PREVOST

WARRANTY BULLETIN

WB24-36

DATE:	April 2025	SECTION:	01 ENGINE
EXPIRATION:	April 2027		
SUBJECT:	SECONDARY ENGINE INFORMATION LABEL REPLACEMENT

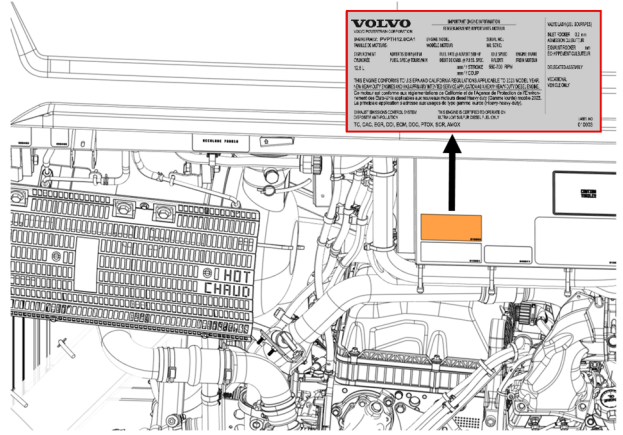
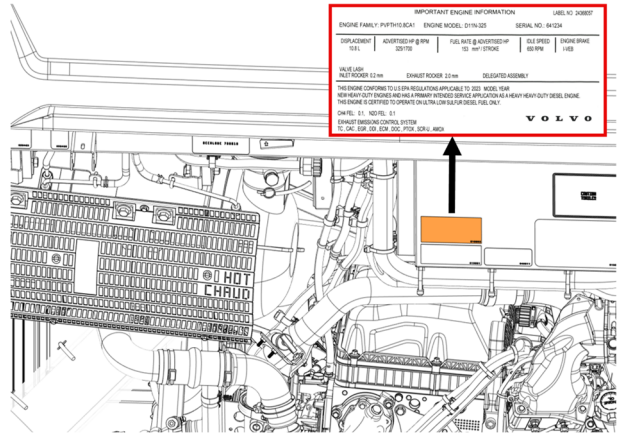
On the vehicles affected by this bulletin, the secondary engine label has typing errors and needs to be replaced.

4. Locate the secondary “IMPORTANT ENGINE INFORMATION” label to be replaced.
5. Ensure that the engine serial number on the existing and new label is the same.

6. Use a scraper to entirely remove the existing secondary engine label.
7. Clean the surface with an adhesive remover.

8. Carefully affix the new secondary engine label at the same location.
